STAFF REPORT
(One-Step Final Plat)

CASE NUMBER: S/D 00-01 -- LUDLUM 1ST ADDITION

LOCATION: East side of 375th St. West, North of 31st St. South

VICINITY MAP

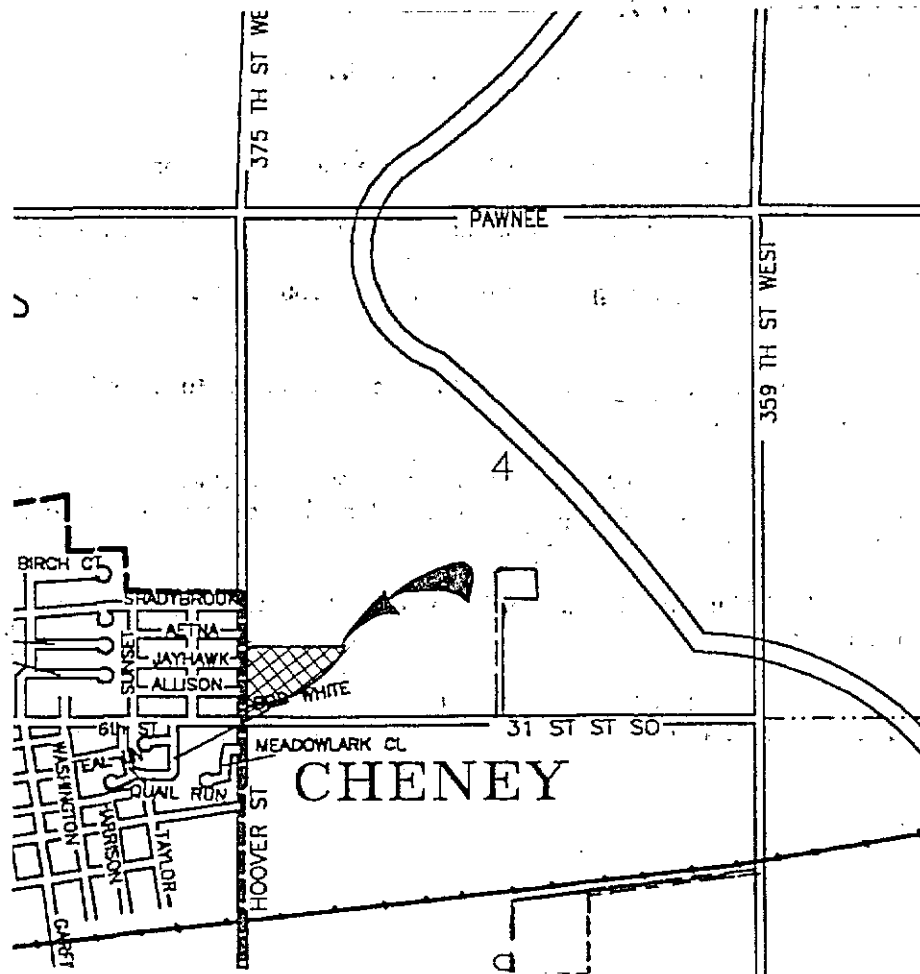
- D. **County Engineering** needs to comment on the status of the applicant's drainage plan. *The Floodway easement needs to be relabeled as a Floodway Reserve. The limits of the Floodway Reserve need to be labeled and dimensioned. The lowest floor or minimum building elevations need to be established as applicable. A HEC Quick-2 flood study run needs to be completed. A Floodway reserve easement agreement needs to be submitted.*

- E. The plat proposes one access opening per lot along 375th St. West. The platting text shall reference "one opening per lot" and denote access controls as being dedicated to the appropriate governing body.

- F. Lot line dimensions need to be revised for the north and south lines of Lot 1 and along the southerly line of Lot 2.
- G. The owner's certificate shall reference the language "platted into lots" and include a signature line.

- M. The MAPC signature block should be revised to reference "Francis S. Garofalo" as the MAPC Chairman.
- N. The legal description needs to be revised to accurately portray the land being platted. The distances on the drawing need to correspond with those denoted within the legal description.
